From: Zaccor1@aol.com  
Sent: Monday, September 29, 2003 3:12 PM  
To: agholami@co.alameda.ca.us; john.cavanaugh@erm.com  
Subject: 2415 Mariner Square, Alameda

Re: Mariner Square Marina Loan, Second Deed of Trust

**From:** Chu, Eva, Env. Health  
**Sent:** Wednesday, July 03, 2002 10:12 AM  
**To:** Mawhinney Helen (E-mail)  
**Subject:** 2415 Mariner Sq, Alameda, CA

<b>Earth Systems Consultants</b> Northern California	Mariner Square Alameda, California		<b>SITE PLAN</b>	
	Date: May 1999 File No: NFE-4392-01	Figure 2

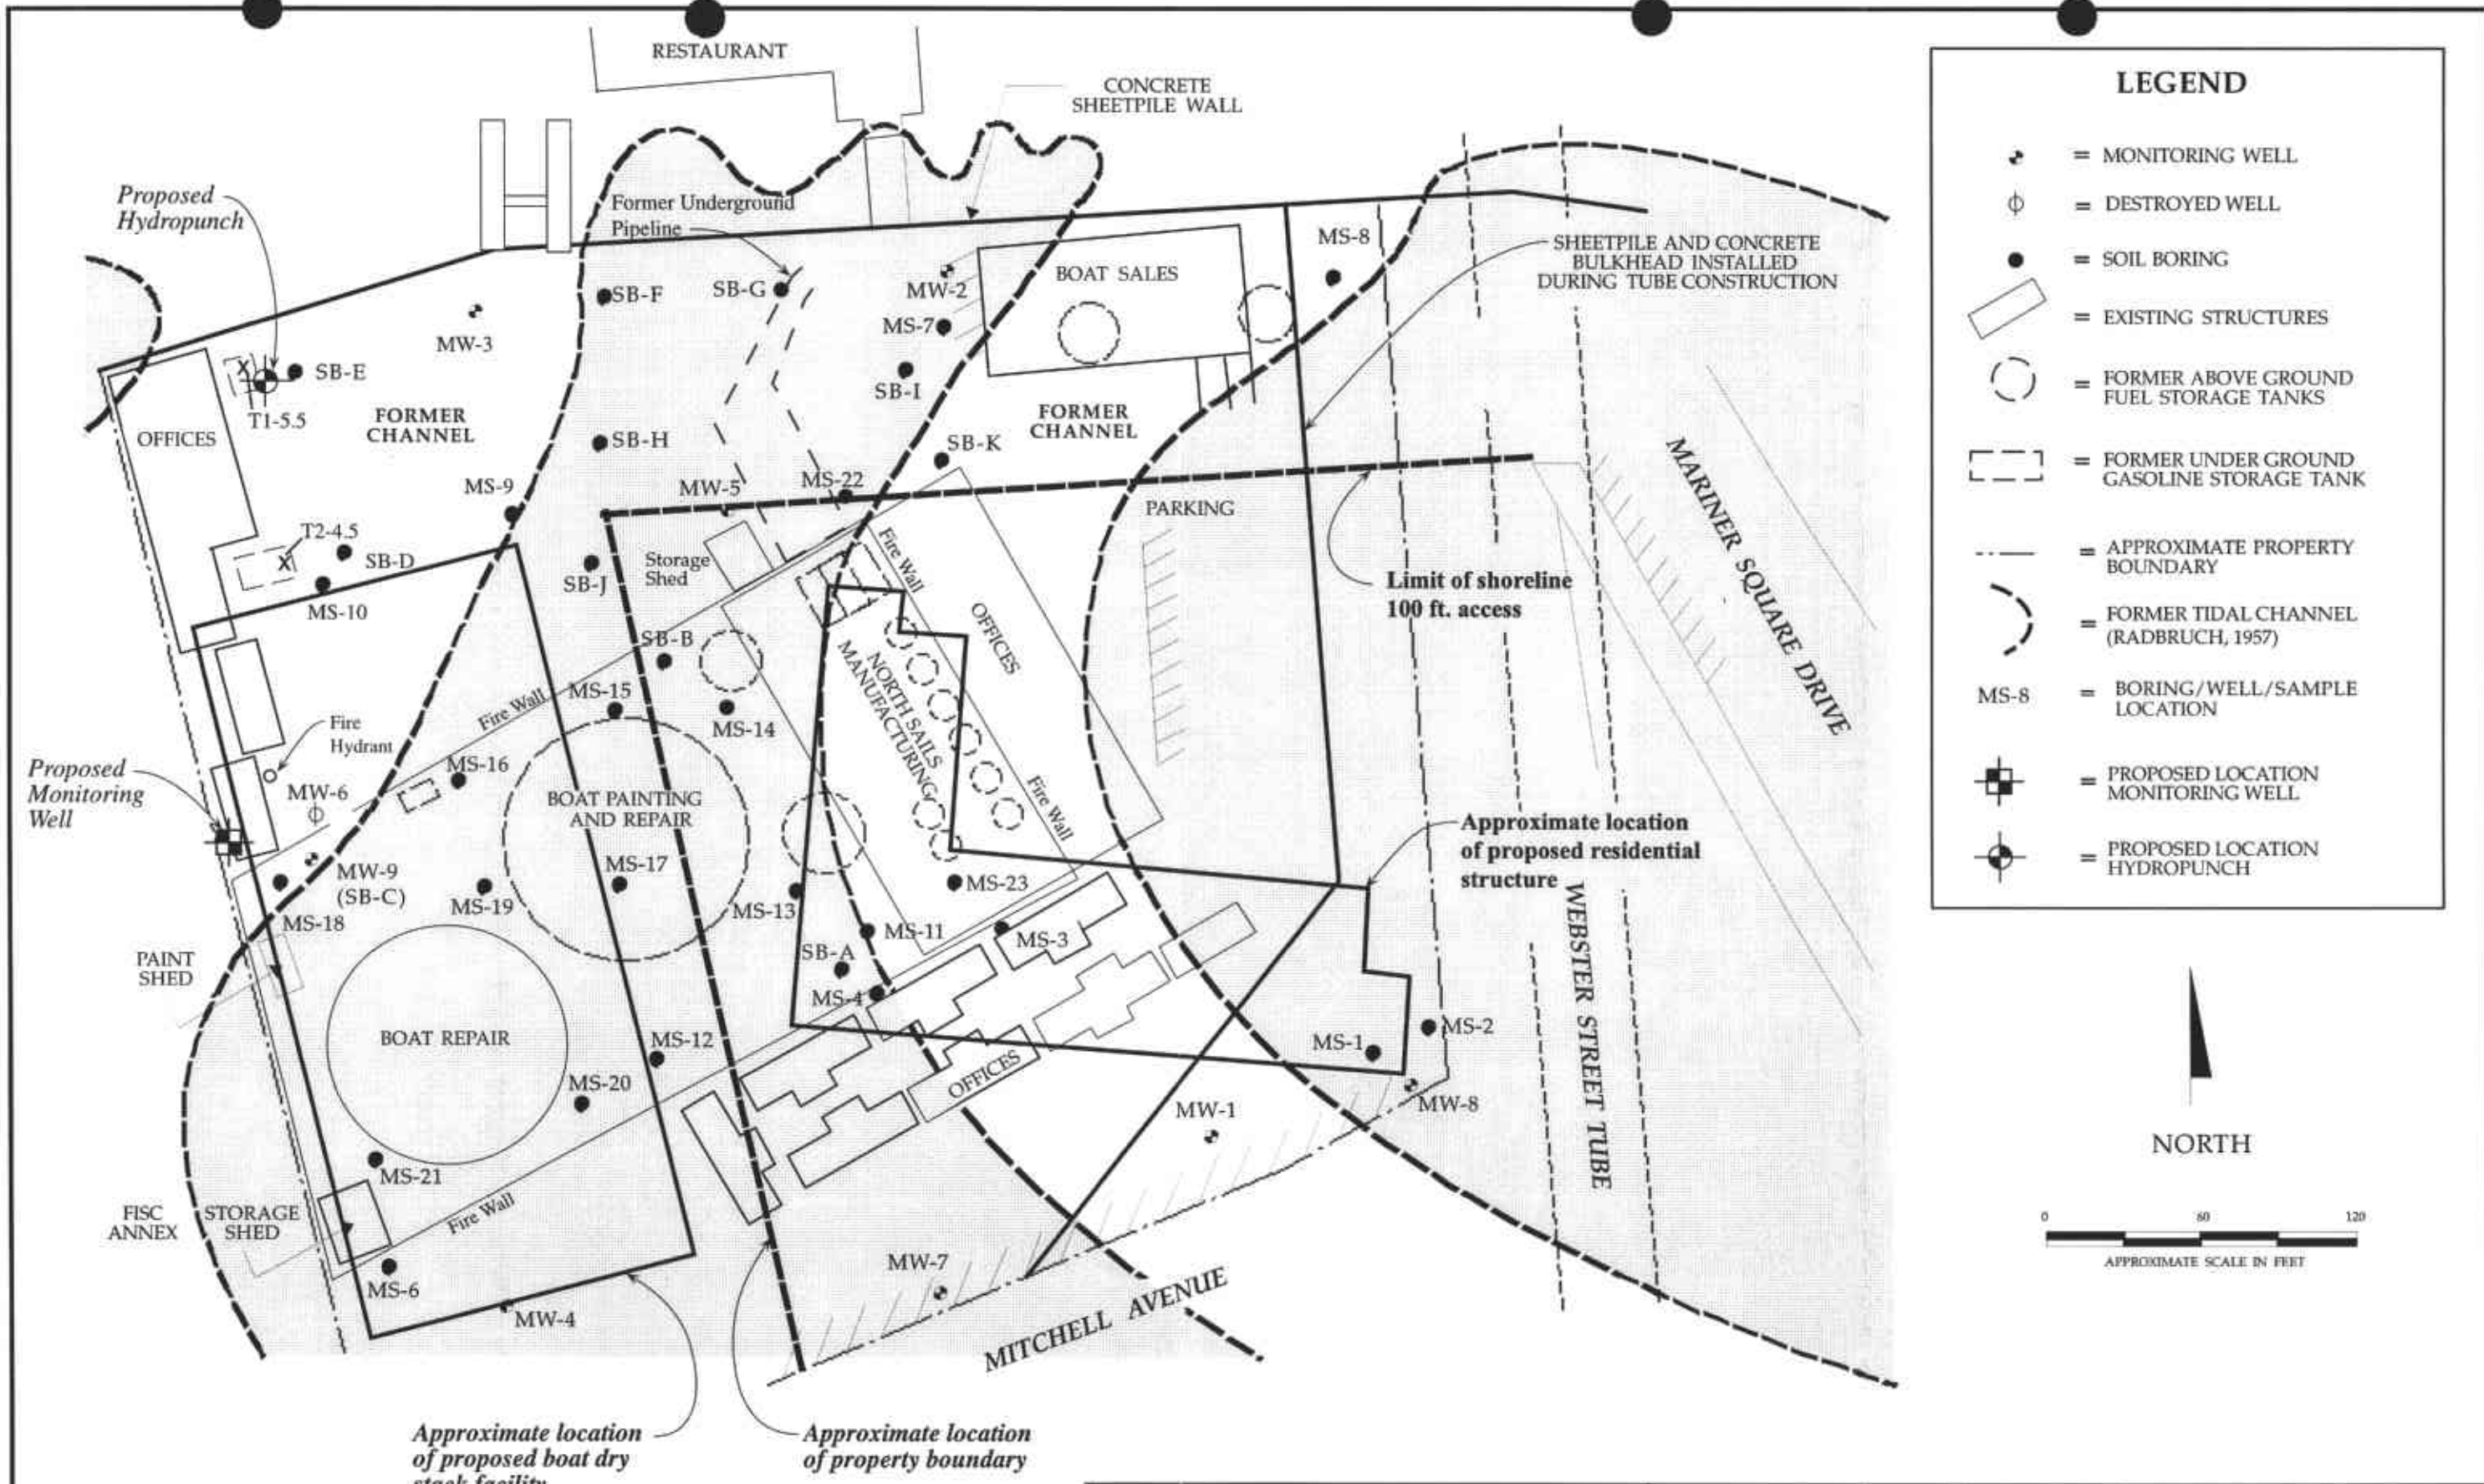
The site was divided into two parcels based upon expected future use: 1) a western industrial use parcel, and 2) the eastern residential use parcel (Figure 2 from the February 1999 report). After the meeting, the eastern parcel was revised to not include the one-hundred foot shoreline setback area. The shoreline setback area is included in the western parcel.
